Metropolitan Planning Commission

Staff Reports

March 13, 2008

2008S-007U-03
VILLAGES OF EWING CREEK
Map: 059-00 Part of Parcel 063
Subarea 3
Council District 2

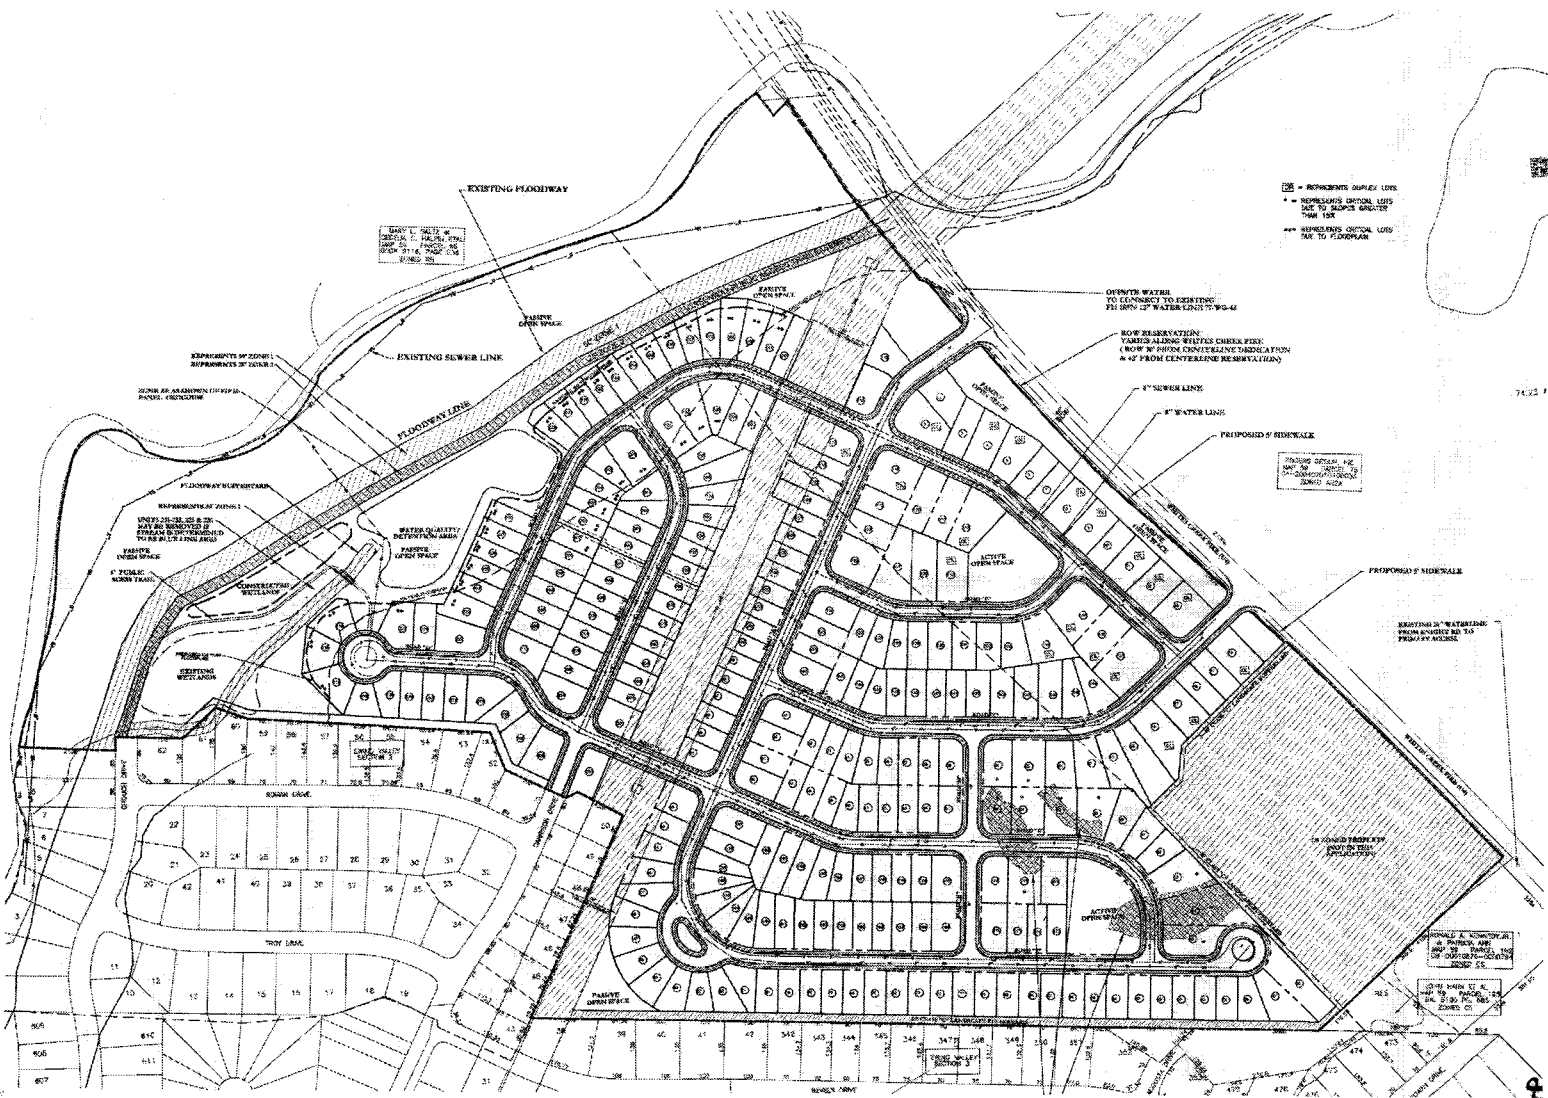
The Stormwater Division has noted that the buffer shown within the wetlands and the stream adjacent to lots 218 and 219 are incorrectly depicted. The required increased width will impact both lots 218 and 219. These lots cannot encroach into the buffer and must either be reconfigured to be completely outside of the buffer area or removed from the plan.

1. Consolidate all pertinent stormwater related details onto the Stormwater Grading and Drainage Sheet (C4.0). Zone 2 of the Floodway Buffer represents more than the "Greenway Public Access Trail Easement Area", it needs to be defined also as a 25' Floodway Buffer. Sheet C4.0 should label the Floodway, the, "50' Floodway Buffer - Zone 1," and the, "25' Floodway Buffer - Zone 2."
2. With reference to Page 12 of Chapter 6 of Volume 1 of the Stormwater Management Manual, show and

- label a, "25' Water Quality Buffer" for the existing Wetlands.
3. The stream, as identified by Metro GIS ArcMAP, present within the noted wetlands is incorrectly depicted. With reference to Page 12 of Chapter 6 of Volume 1 of the Stormwater Management Manual, show and label a "30' Water Quality Buffer." The Water Quality Buffer is scaled from the Tops of Bank. The total required buffer width is 30' + 30' + the top width of channel. The current Buffer is only 30' in width. Appropriate Correction is required.
 4. With reference to comment #3 above, the increased buffer width of the noted stream will affect Lots 218-219. Said lots cannot encroach into the buffer. Either remove the lots from the buffer or reconfigure the Lot layout.

1. Show on plans, planned building construction type, and square footage.
2. Actual or projected flow data shall be provided on plat showing compliance with 2006 edition of NFPA 1 table H.

3. Print fire hydrant flow data on plans.
4. Provide a Master Water Plan which shows water mains, fire hydrants, and the proposed flow from the fire hydrant with the highest elevation and most remote in this project, street access, and topographic elevations.

1. Seven of the lots identified as duplex lots shall be changed to single-family lots, including Lots 12 and 111. Duplex lots shall be located at corner lots and not grouped along any one street or in any one area.

4. Stormwater requirements shall be met prior to concept plan approval including the reconfiguration or removal of Lots 218 and 219 so that no lots encroach into the required buffer areas.

2006P-013G-02
CONE PROPERTY
 Map: 050-00 Parcels: 129,146,091
 Subarea 2
 Council District 3

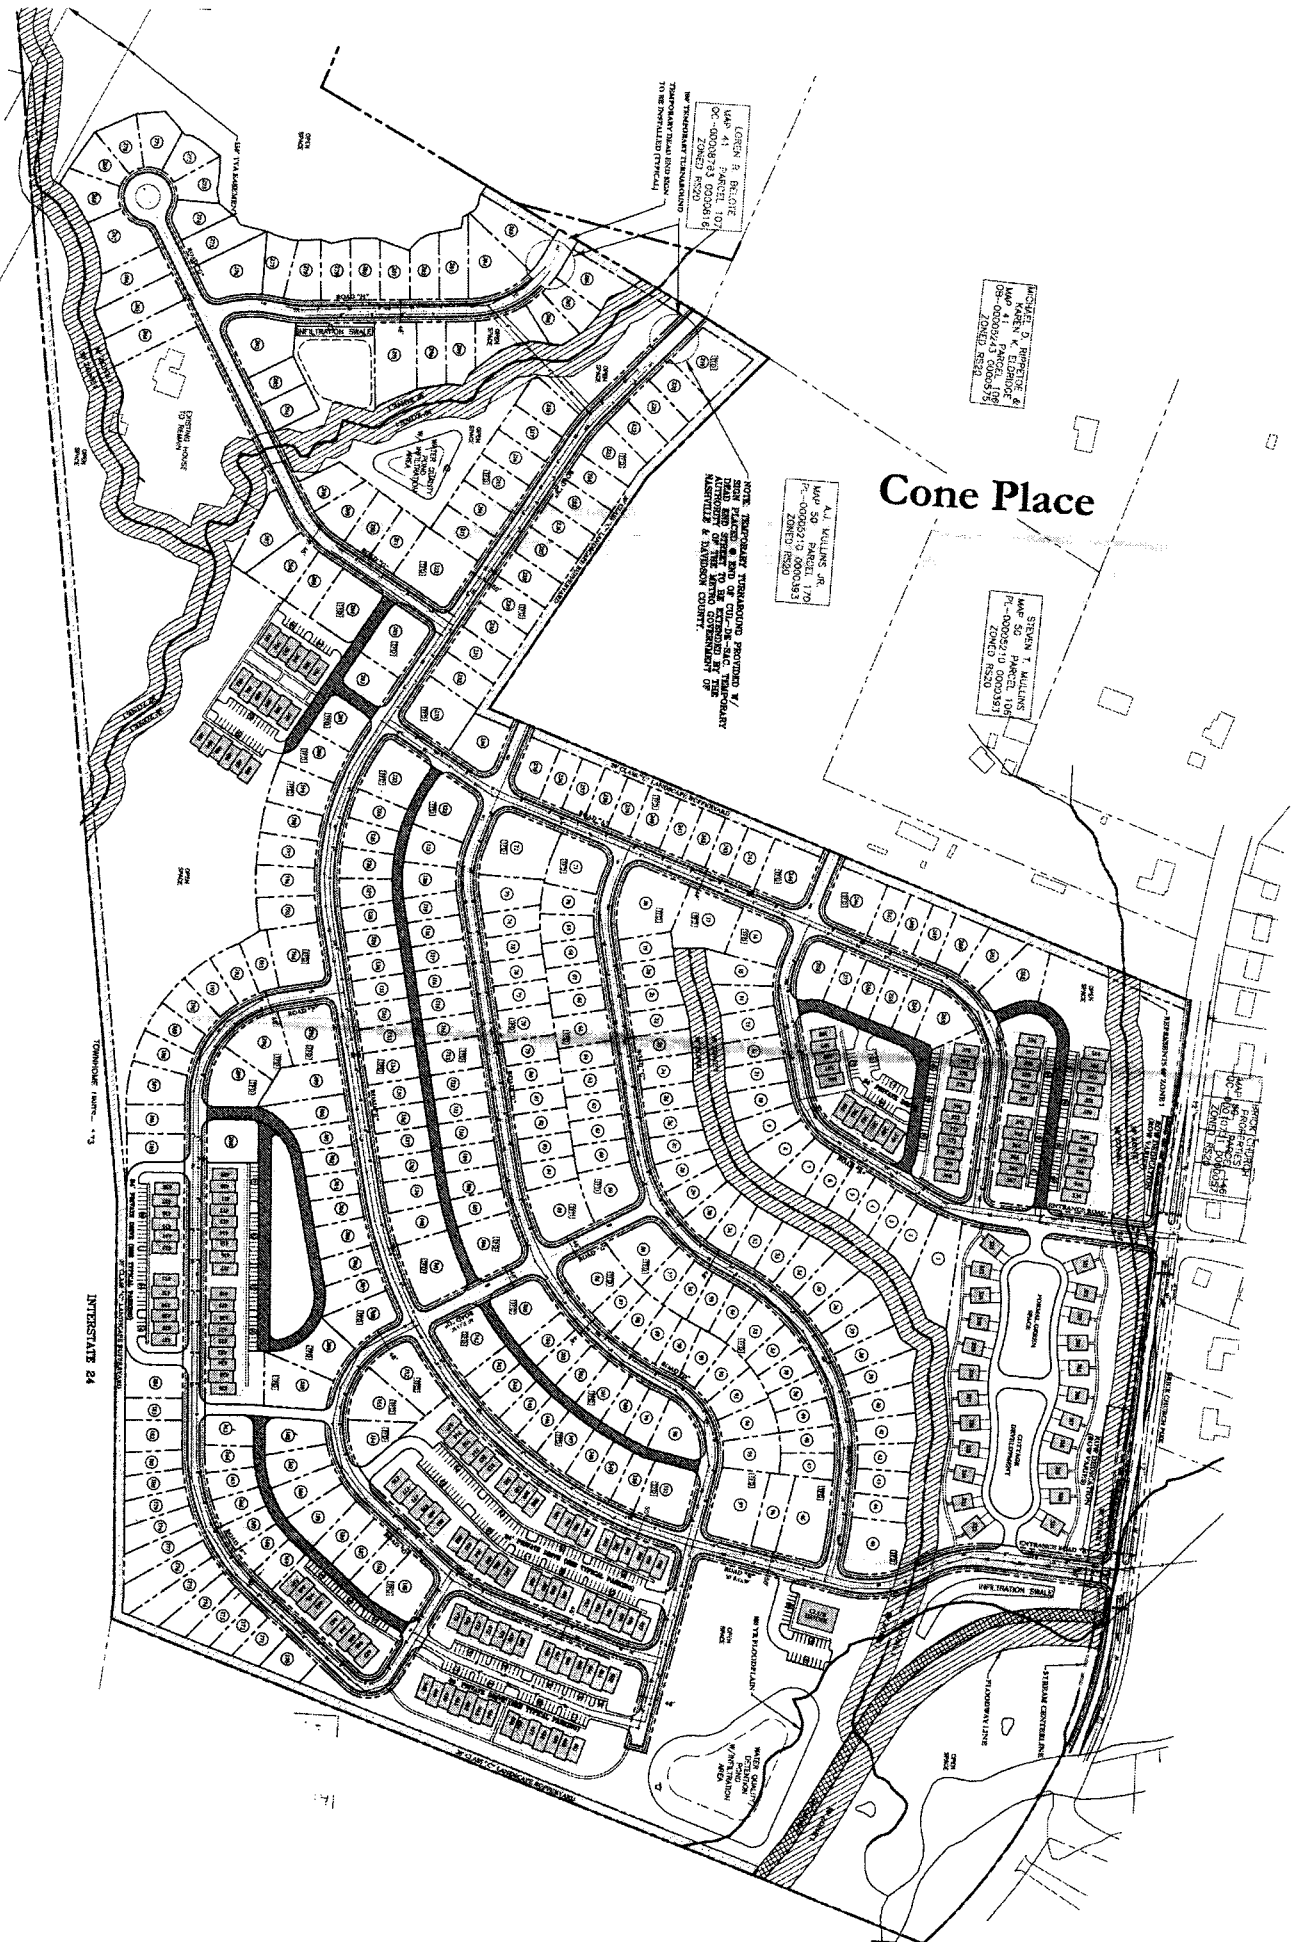
The plan proposes 255 single-family lots, 51 duplex lots, 23 cottage units, and 173 townhomes located on approximately 189.64 acres. Approximately 83.34 acres will be open space. The cottage units are to be located on the eastern edge of the site and the townhomes are to be located in four pockets on the eastern, western and southern edges of the site. The lot table provided with the plan does not accurately reflect the lot count. A corrected lot table must be provided. In addition, the plan does not show the correct acreage for the three parcels, which also must be corrected on the revised preliminary plan.

The cottage units are in two rows, with rear access from a drive surrounding a green. While the front units face Brick Church Pike and provide the entrance to the PUD, the rear units appear to face the rear or side yards of the adjacent single-family lots. In some locations within the proposed PUD, building types should be relocated to create a stronger streetscape with compatible types of lots on both sides of the street. There remain unresolved design issues with the cottage portion of the PUD and with the creation of strong streetscapes. Prior to approval of the final PUD site plan, the Planning staff must approve revisions to the design to address these issues.

A number of elements are missing from the plan and must be added. These include the identification of all proposed and existing sewer and utility lines on site plan, labeling of fire hydrants, screening details for dumpster receptacles, a development schedule for phases of construction, and Floor Area Ratio and Impervious Surface Ratios for the development.

The plan also shows an adequate internal sidewalk system which will allow ease of pedestrian movement regarding the residential portions of the development. An alley system will allow for rear access to some of the lots. The alley shown between Lots 162, 163 and 310 must be converted to a public street with sidewalks.

The Historical Commission has serious concerns with the treatment of the historic house and outbuildings (which are not shown on the plans) and recommends that the house and outbuildings be retained together on enough acreage to

retain its rural setting. The recommendation is a lot size of at least 10 acres, preferably more, with buffering from the new development. As it is shown now, the house parcel appears to be too small, and greatly encroached upon by proposed lots 264-294, most specifically 264-276 and 292-294.

- Provide accurate lot count for all residential units, correct lot table to include lots shown on the plan, and correct the total acreage of the PUD plan.

- Assign a lot number and include acreage in the lot table for the lot with the Jackson House.
 - Remove lots 264, 265 and 266.
 - Include former name of Preliminary PUD plan in parentheses on title page.

- Convert the alley along Lots 162, 163, and 310 to a public street with sidewalks.
 - Provide identification of all proposed and existing sewer and utility lines on site plan.

- Label all fire hydrants on site plan.
 - Provide screening details for dumpster receptacles.
 - Provide development schedule for phases of construction.

- Provide Floor Area Ratio and Impervious Surface Ratio for development
 - Provide information on the number of bedrooms for the townhouse units but the code so that parking requirements can be determined. Parking for all unit types shall meet the requirements of the Metro Zoning Code.

Preliminary Plan

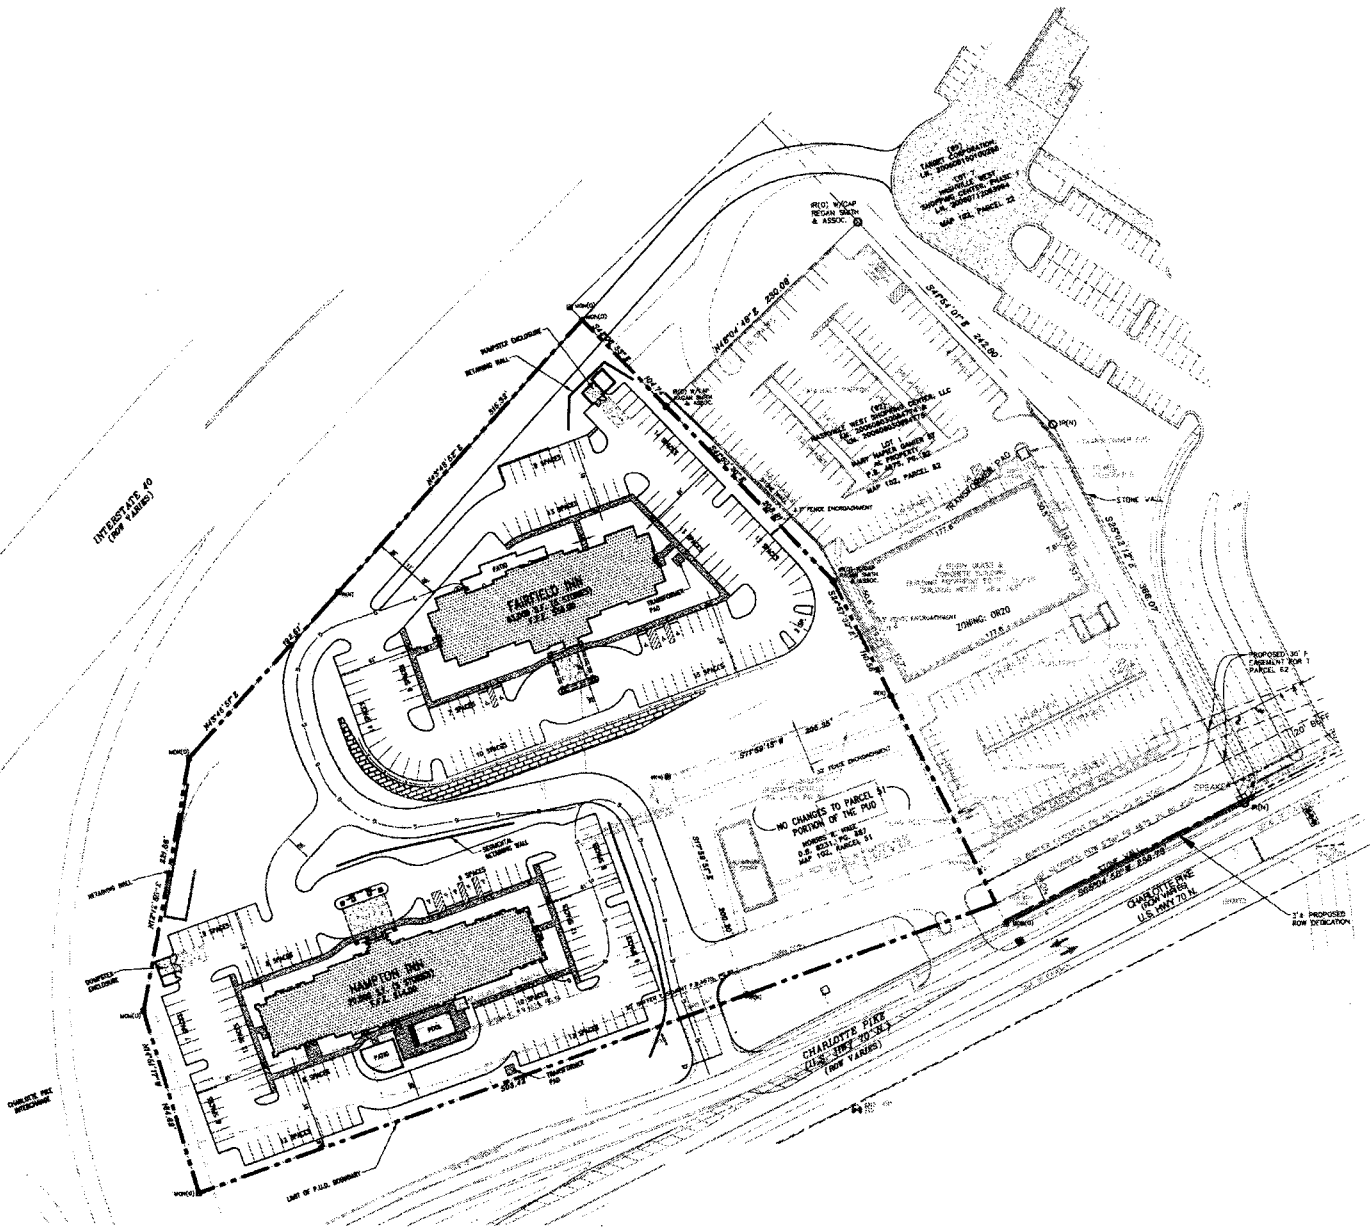
Approved except as noted:
Add Preliminary Note to plans: This drawing is for illustration purposes to indicate the basic premise of the development. The final lot count and details of the plan shall be governed by the appropriate regulations at the time of final application.

1. A sidewalk shall be provided along the private drive to Nashville West Shopping Center and along Charlotte Pike to the western edge of the PUD.
2. This approval does not include any signs. Signs in this planned unit developments must be approved by the Metro Department of Codes Administration except in specific instances when the Metro Council directs the Metro Planning Commission to review such signs.
3. The requirements of the Metro Fire Marshal's Office for emergency vehicle access and adequate water supply for fire protection must be met prior to the issuance of any building permits.

(LOT 1)
 17,609 SQ. FT.
 0.40 ACRES

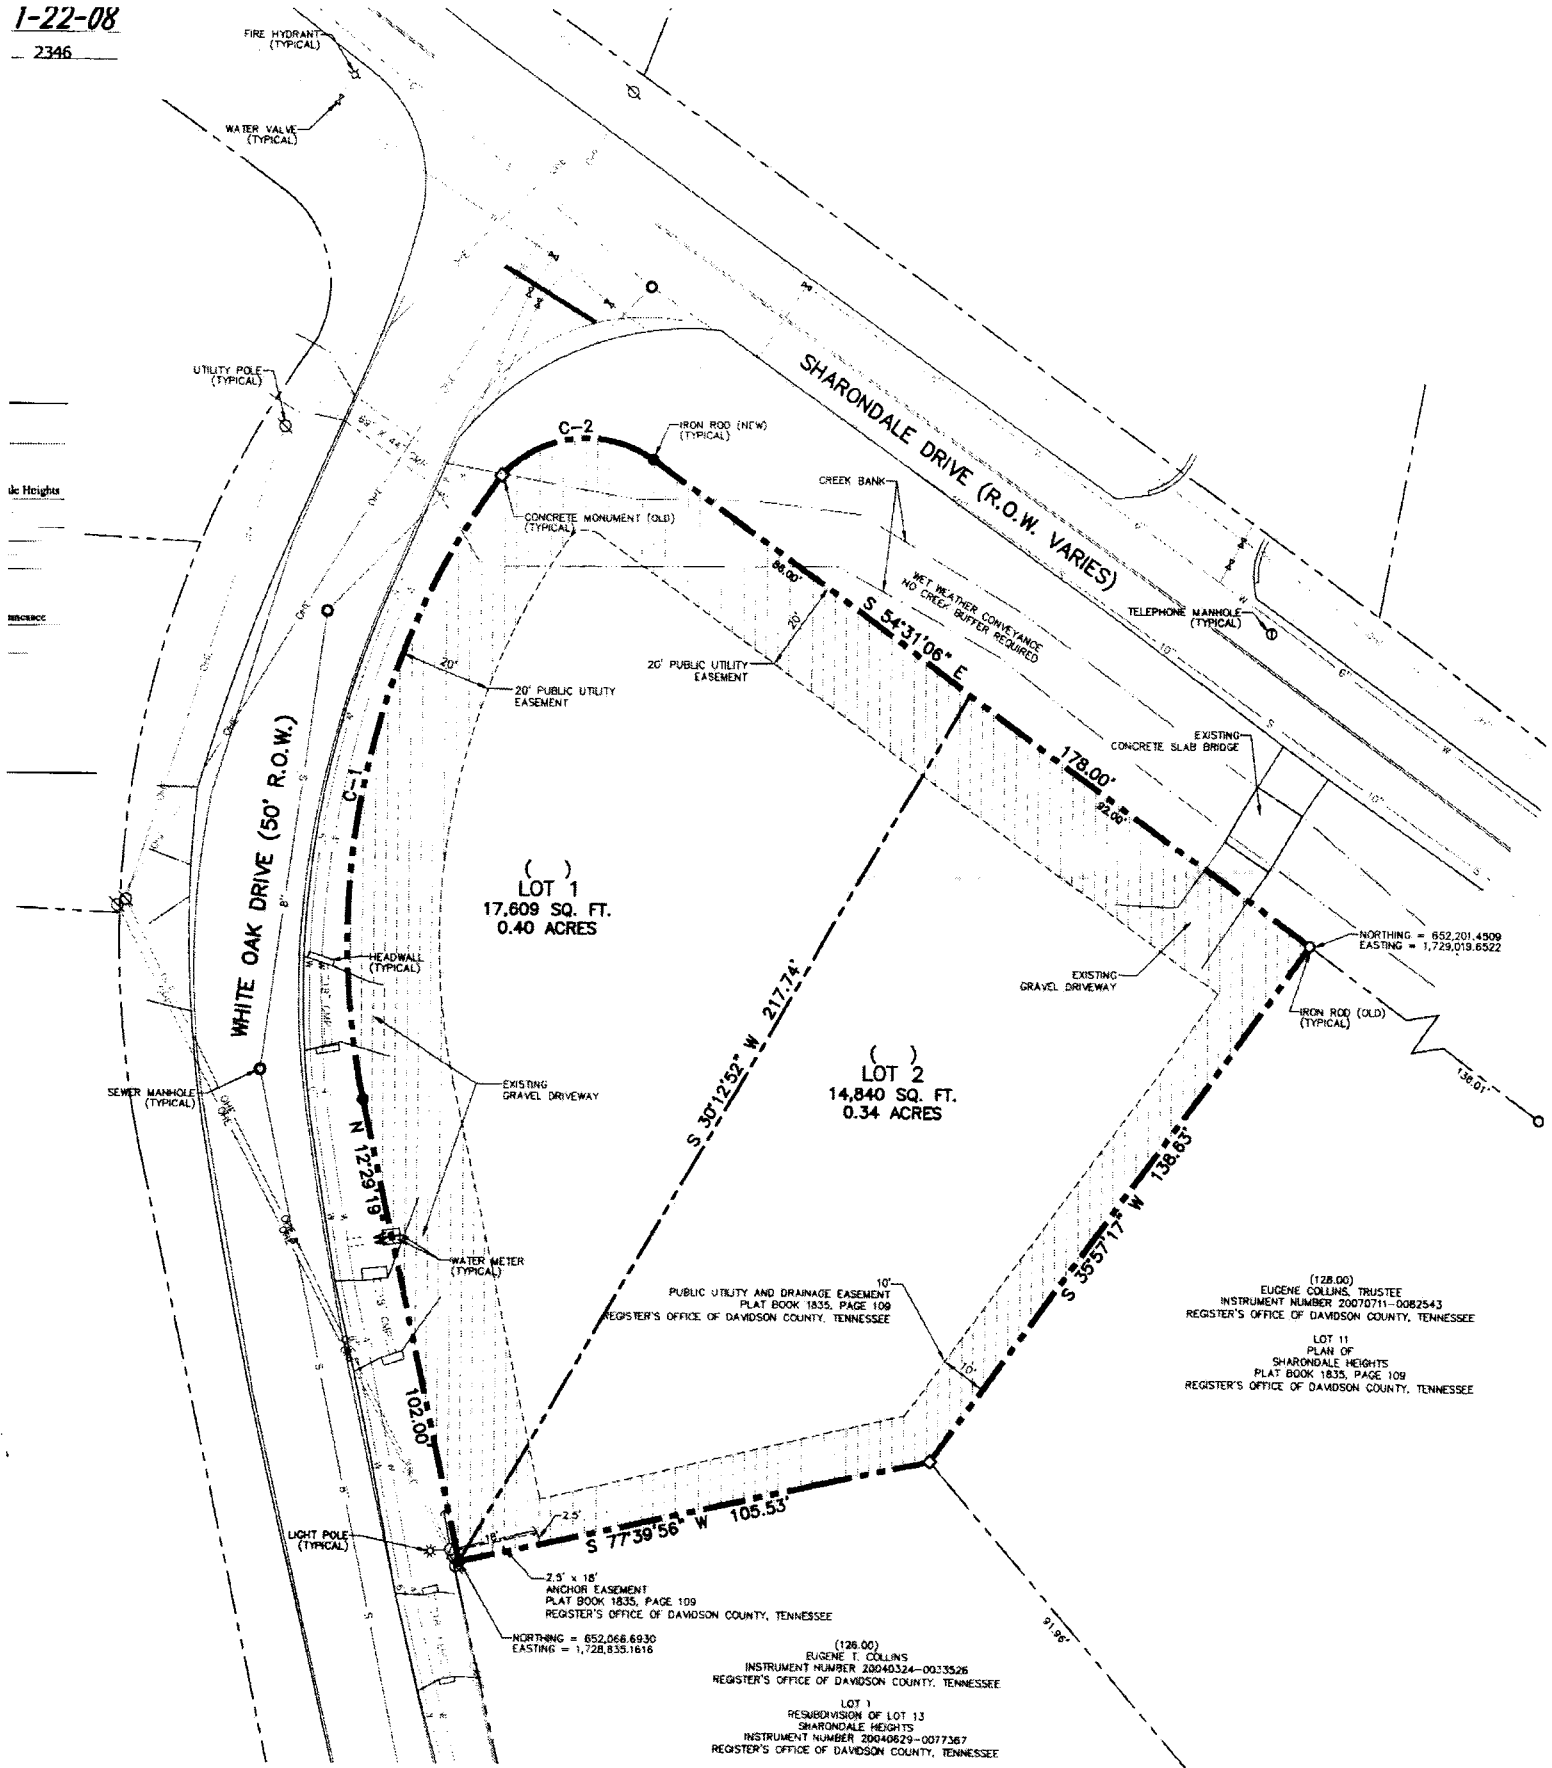
Show and dimension right of way along Sharondale Drive at property corners. Dimension from centerline.
